Burlington Design Advisory Board

ZP-24-276; 206-208 Dale Road (RL, Ward 4) Wild Dale, LLC / Matt Brouillard
Proposed construction of a new duplex on existing vacant lot created under ZP-24-159. (Project Manager, Mary O’Neil)

MEMORANDUM

To: The Design Advisory Board
From: Mary O'Neil, AICP, Principal Planner
RE: ZP-24-276
Location: 206-208 Dale Road
Date: July 23, 2024

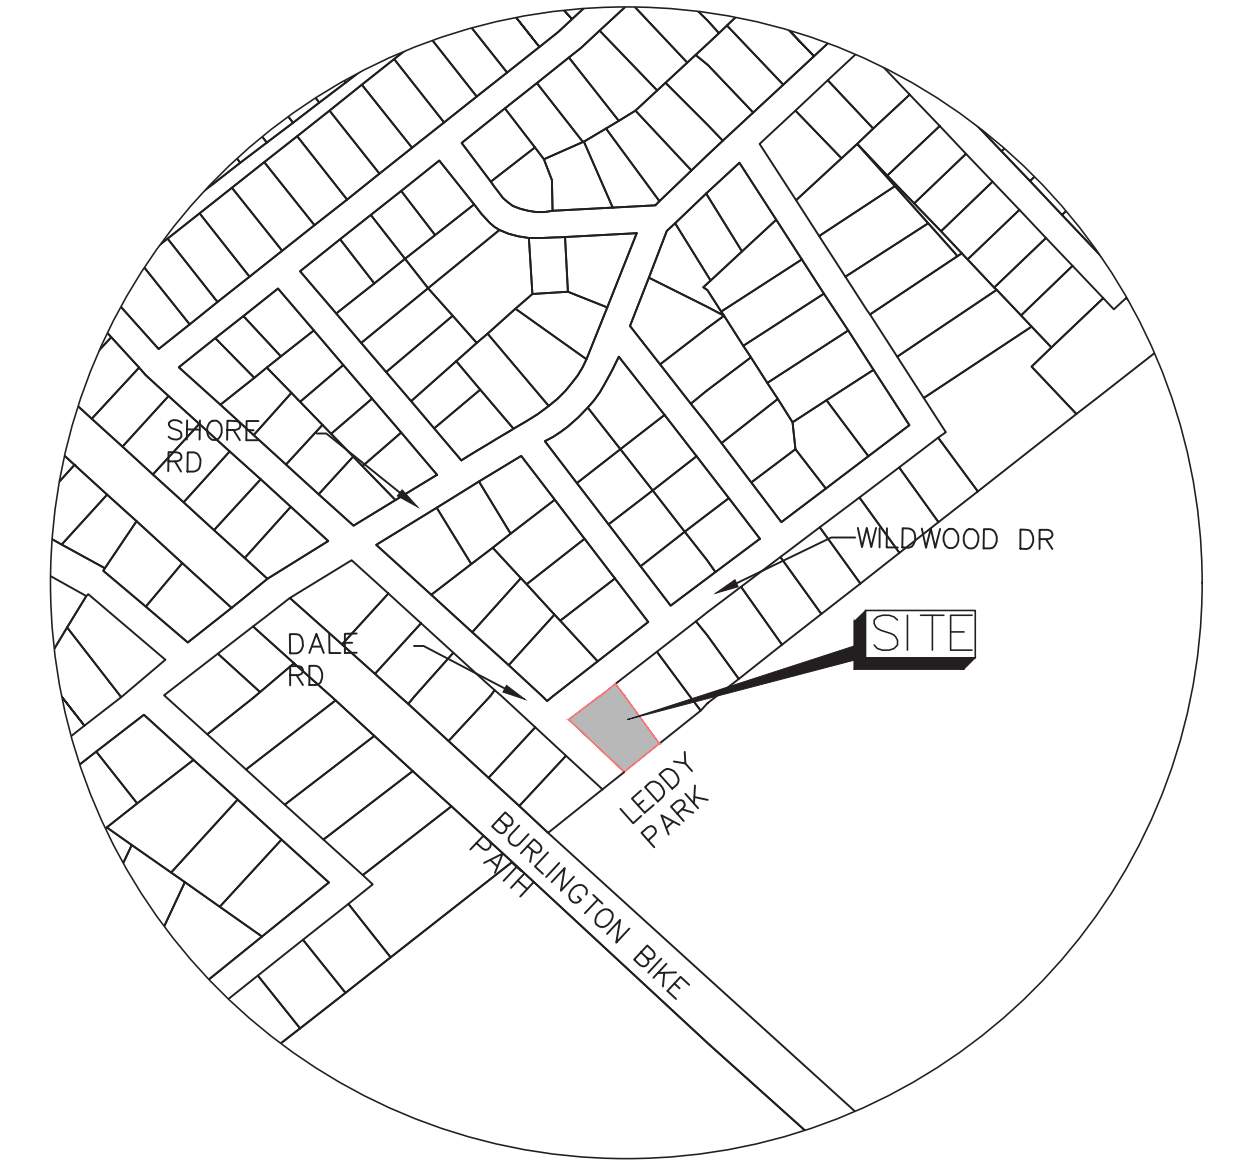
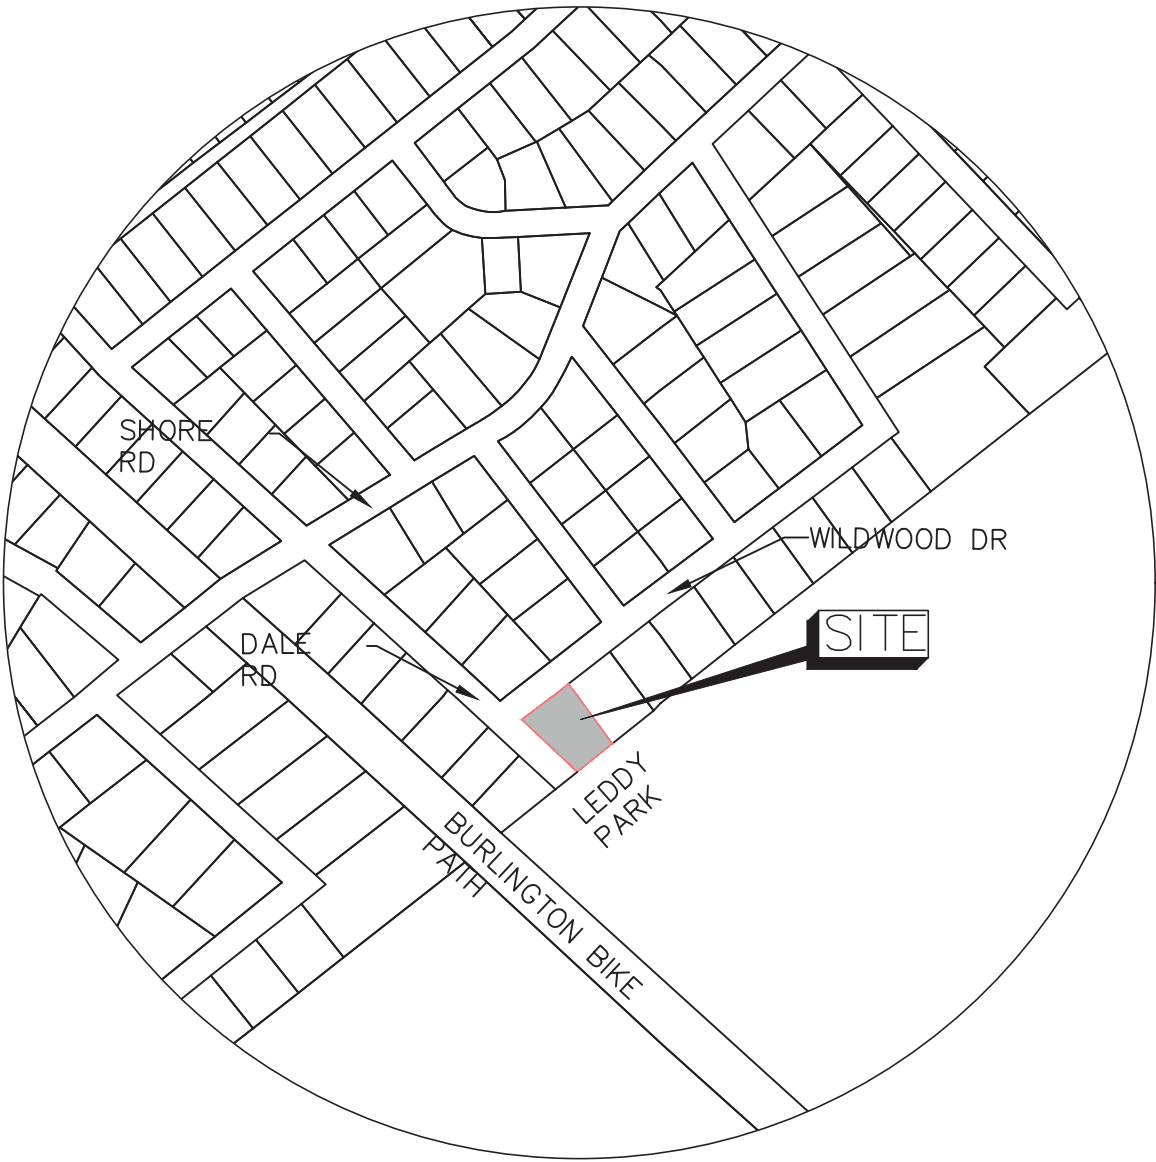
Annotated plan C.-1 illustrates the anticipated Stormwater Flow around the building and onto Leddy Park land. Both the EPSC and Stormwater plan must be approved by the Stormwater Engineering program.

The provided "landscape plan" (C-1, annotated) defines four existing trees in the backyard; existing lilacs along the front property line at the northwest corner, and hydrangeas at each entrance. A Native Vermont Rain Garden is illustrated between the driveways, although no specific planting plan is included for that feature.

2. Both the EPSC and Stormwater plan must be approved by the Stormwater Engineering program.
3. A curb cut permit will be required from the Department of Public Works.

A1.1

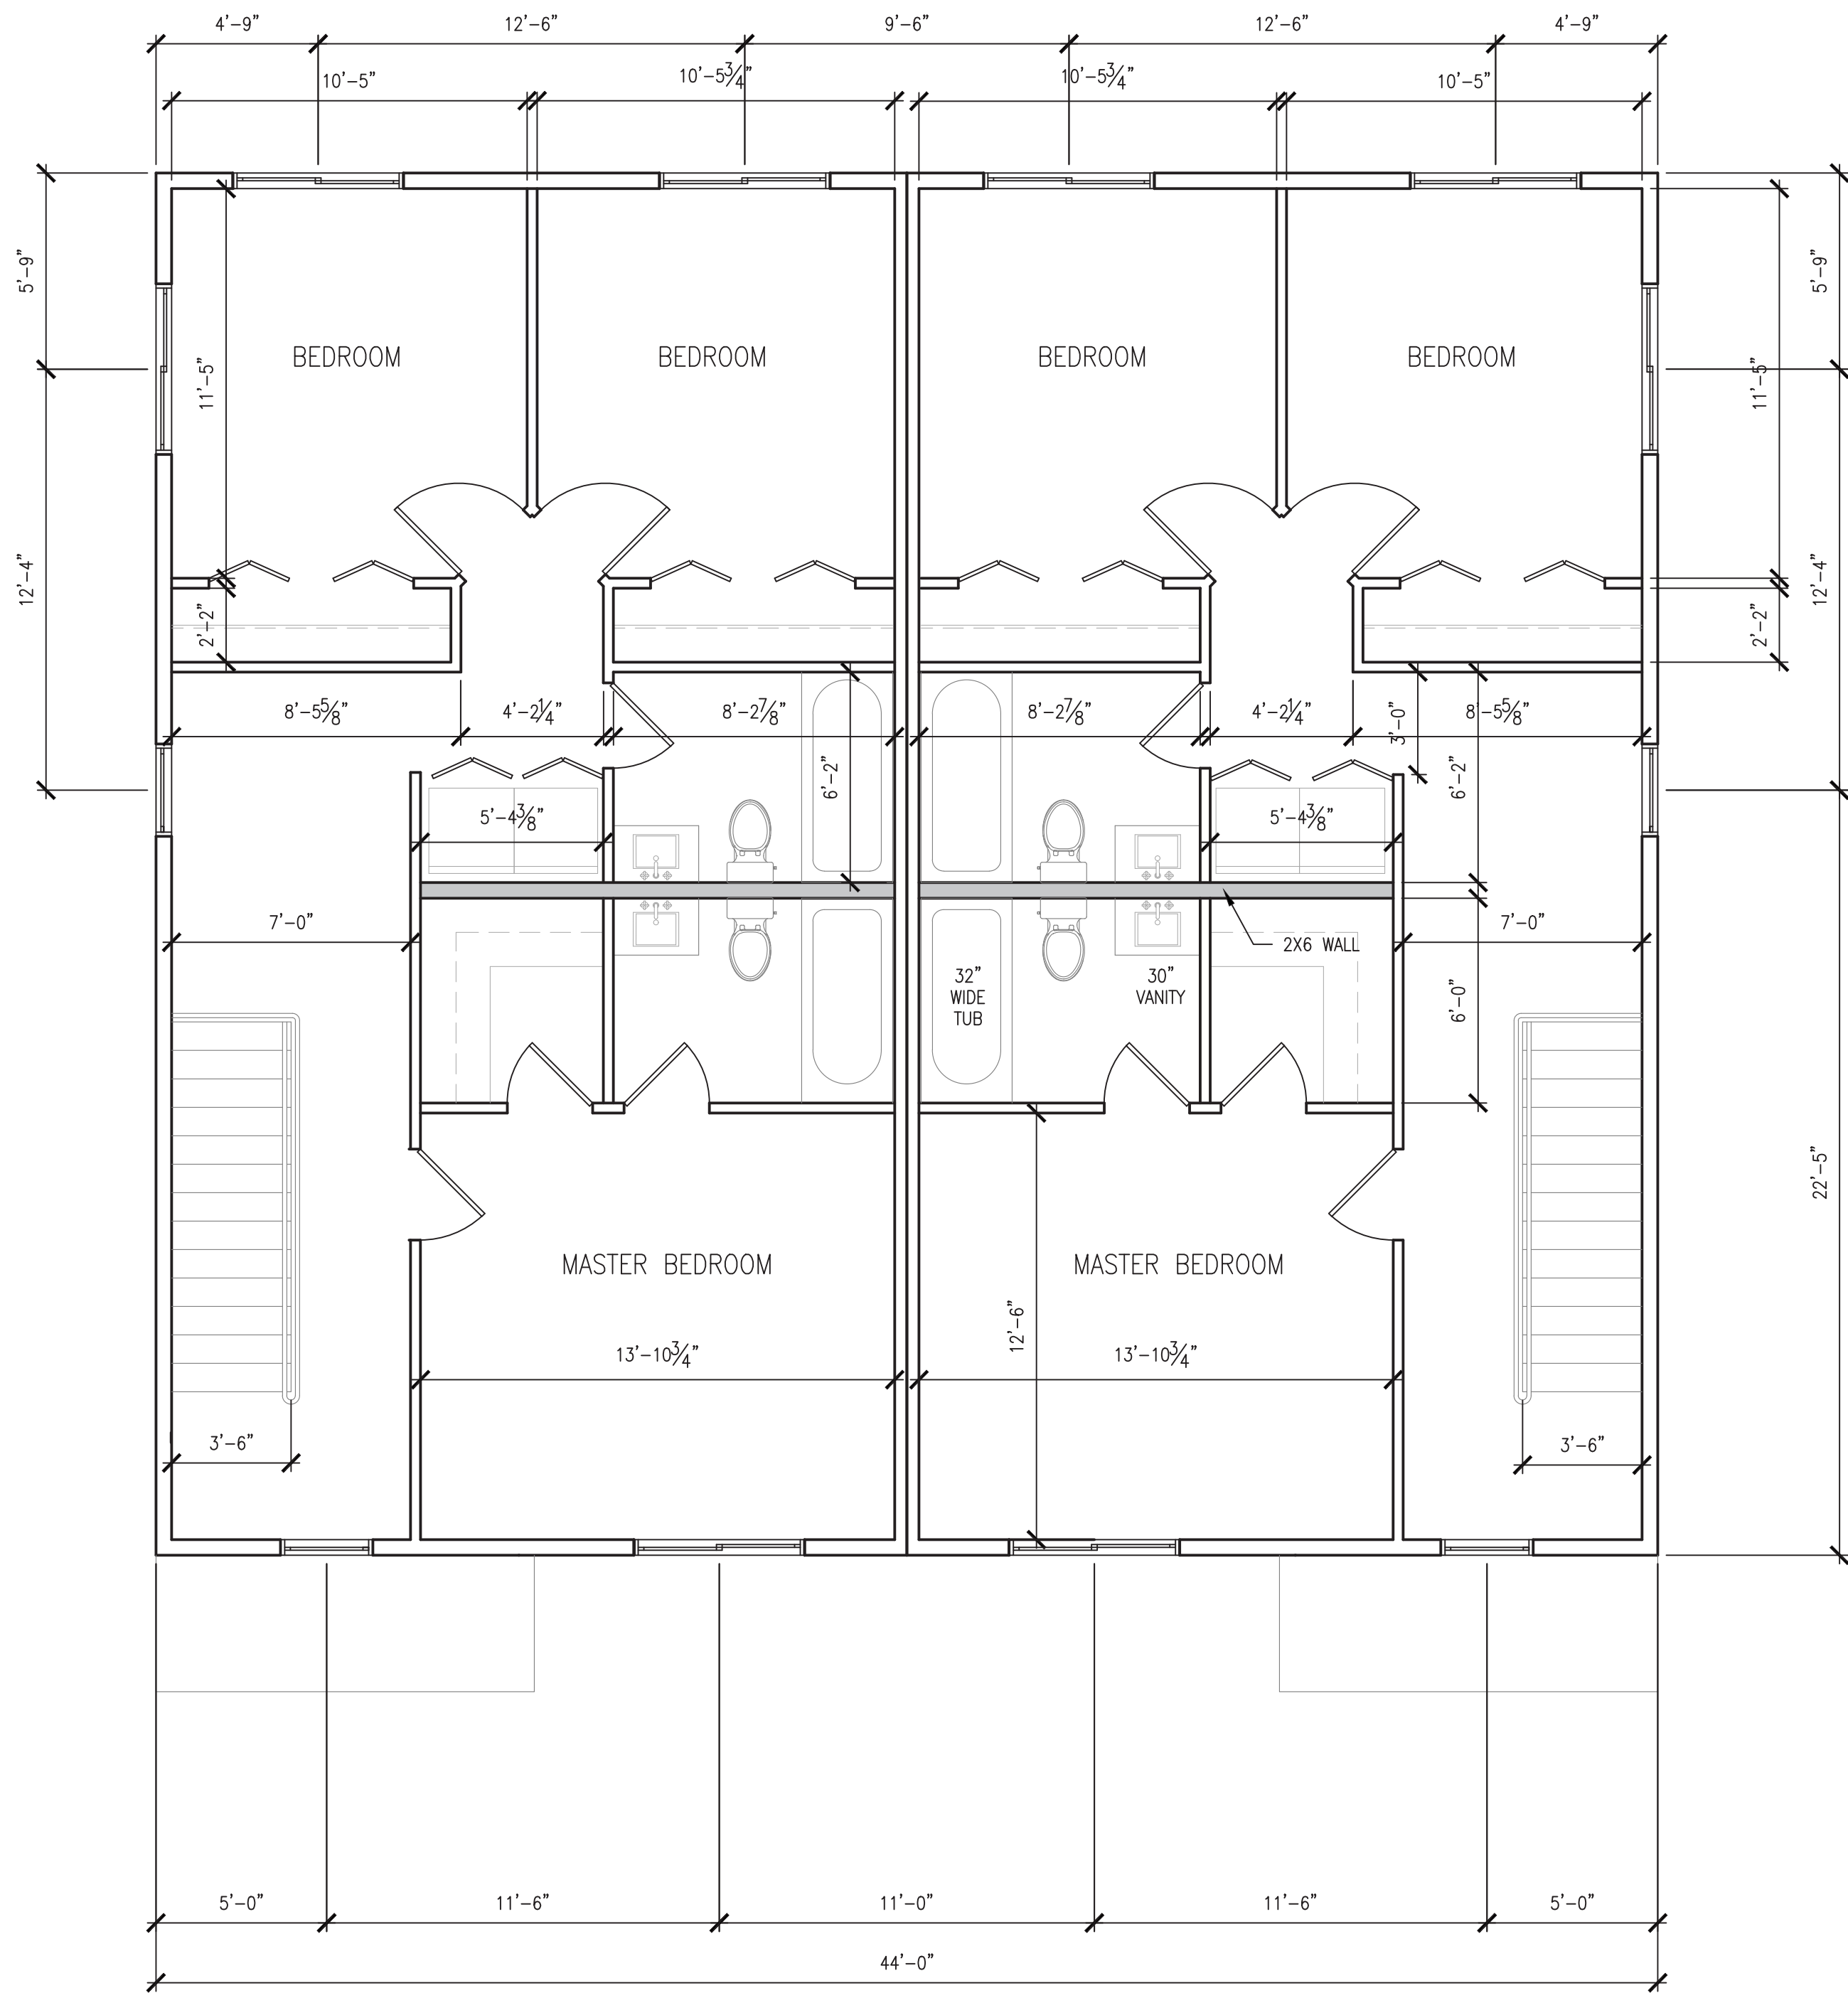
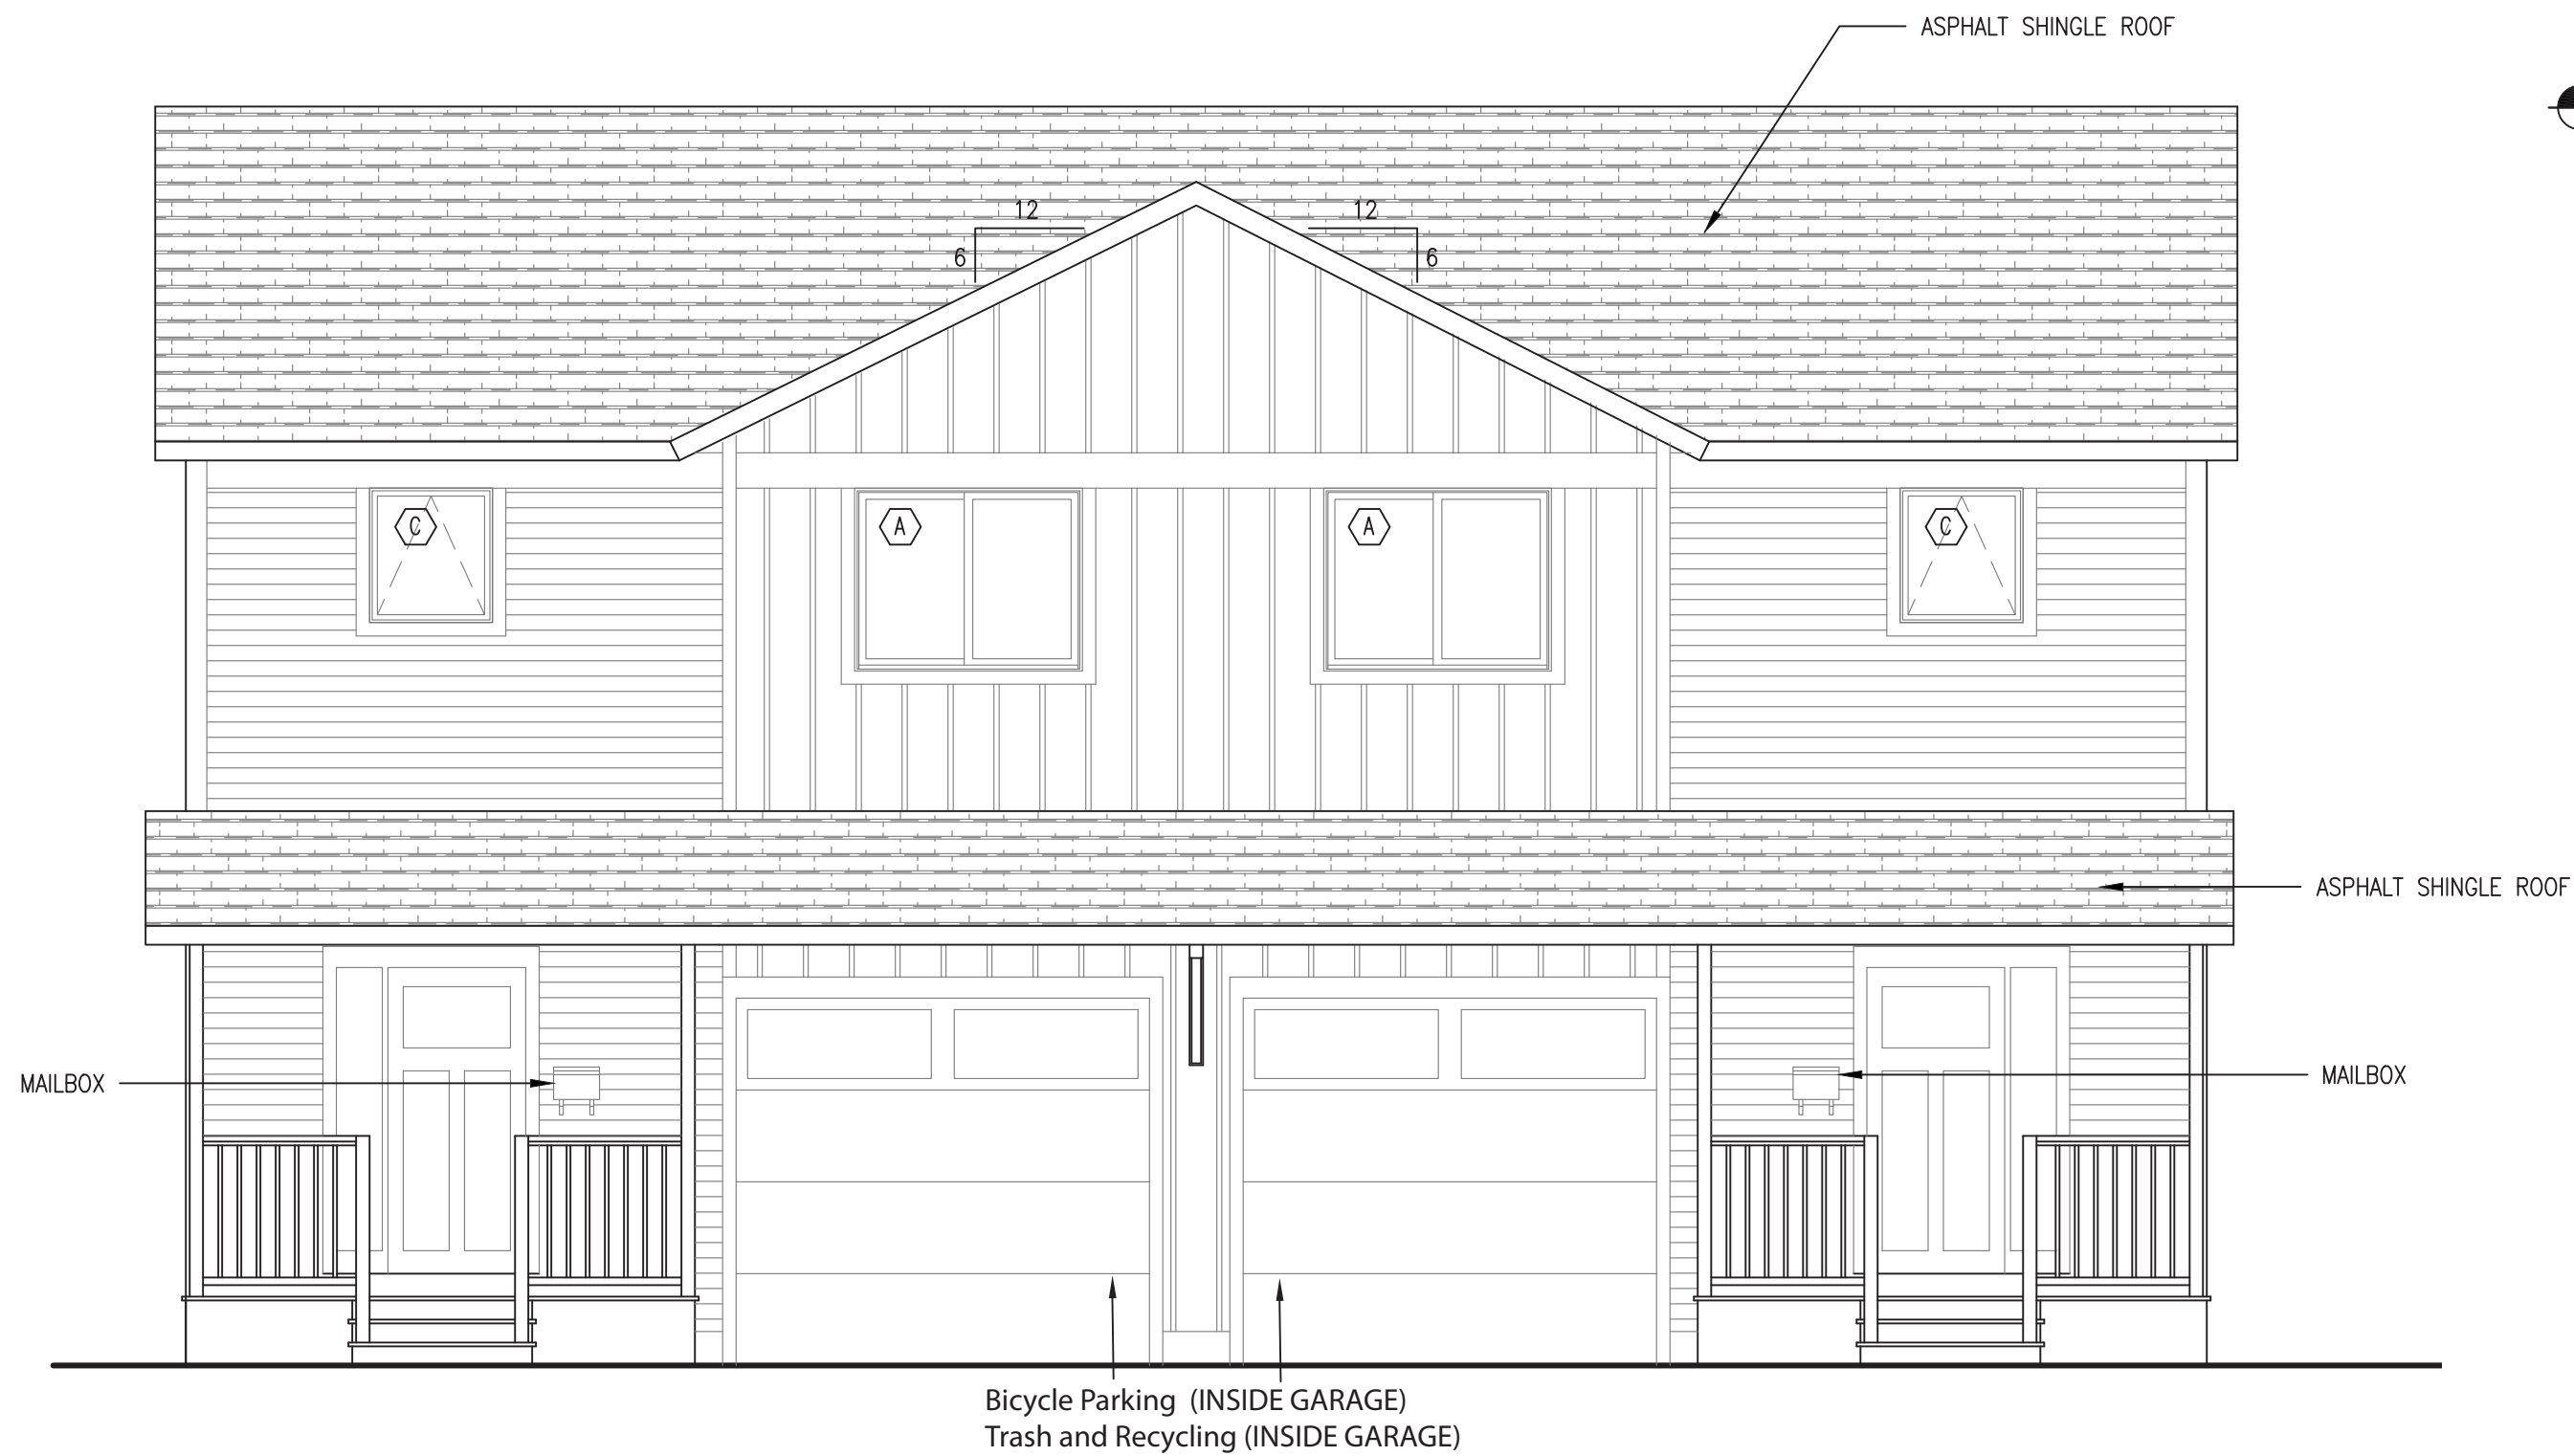
in the original 41 Adams Street triplex review.) This floor plan limits window openings in the Master Bedroom, kitchen, and living/dining areas and creates windowless kitchens and 6 powder rooms. Instead, small windows are provided in hallways (including those on the primary elevation) rather than daylighting living areas. For natural light, air circulation, and an overall improvement in residential comfort, the floor plan is recommended to be revised to:

1. Increase windows in living areas, and
2. Create additional opportunities for natural daylight, air circulation, and overall improvement in function and enjoyment. Moving the interior stairs to interior walls will help provide additional sound buffering between units, provide the opportunity for additional windows to be placed in the kitchen, Master bedroom, and bathrooms, increase natural daylight and air circulation within each unit, and avoid the large expanses of uninterrupted walls on the north and south elevations.

6. A revised floor plan is strongly recommended; placing interior stairs along party walls to accommodate more windows along northwest and southeast elevations. Revisions will allow for expanded opportunities for daylight into interior rooms, increased air circulation, and an improved floor plan allowing greater resident enjoyment.
